Release Notes for entraNET 220 Firmware

Microwave Data Systems, Inc.

Release 3.4.5

Release Date: 08/31/2016

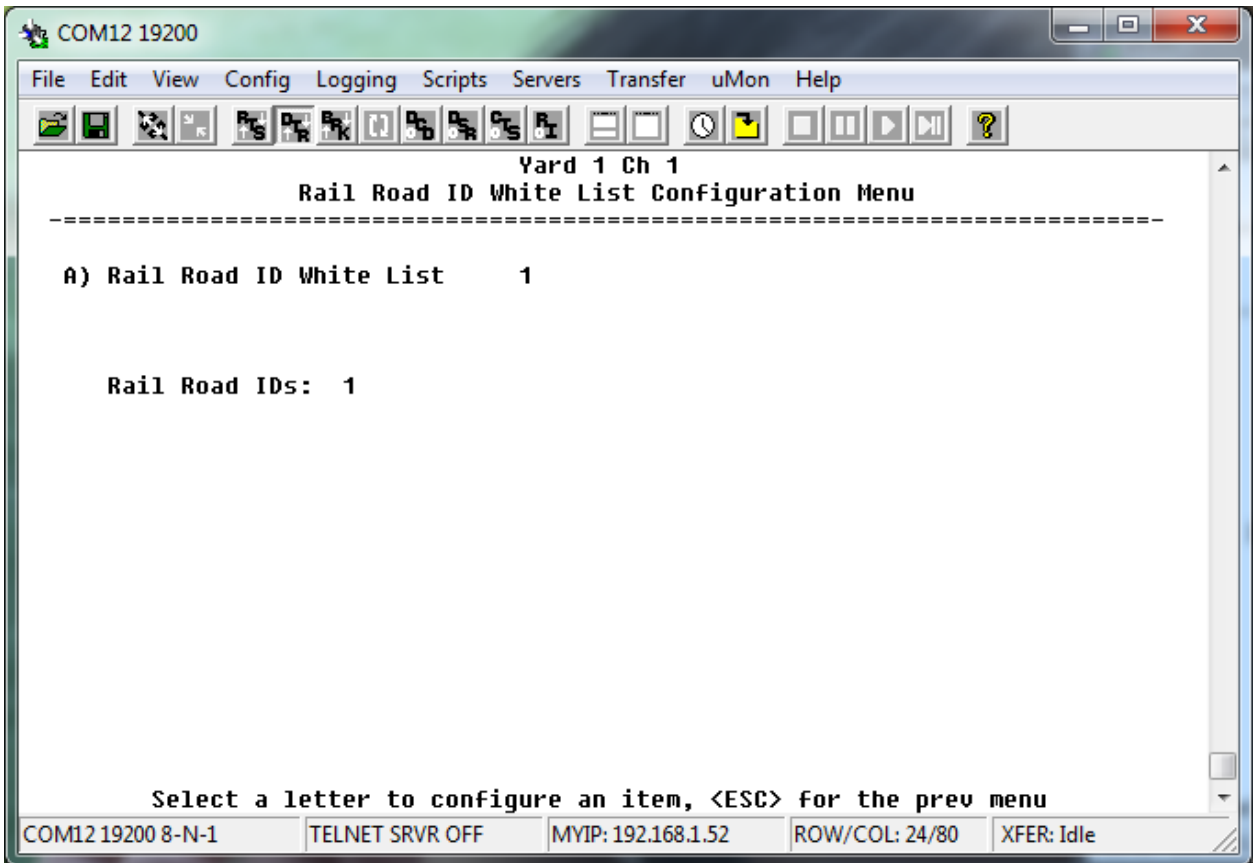
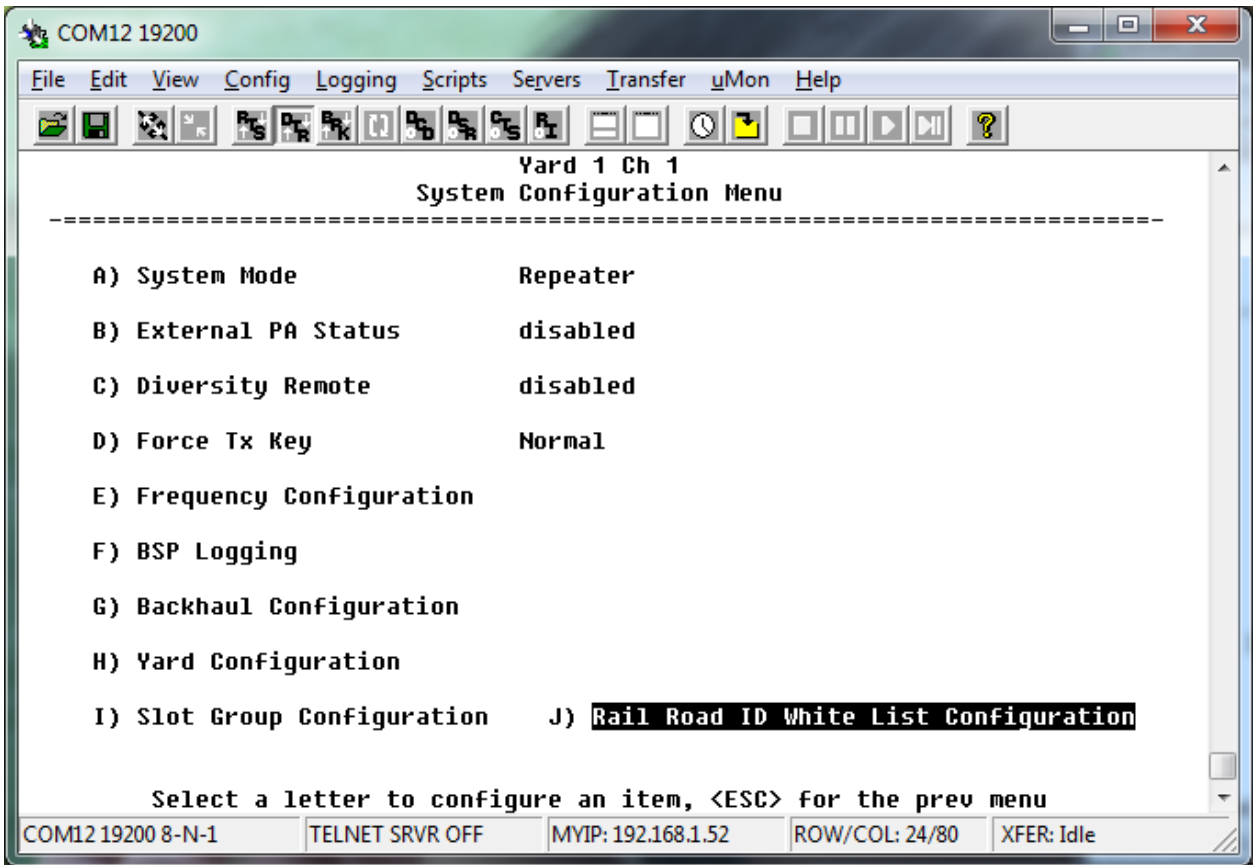
- Added functionality to support the concept of a RRID White List such that the RCS will only accept Slot Group Requests from LCU which have one of the defined RRIDs as part of its System Address.
- Added "Rail Road ID White List Configuration" Screen.
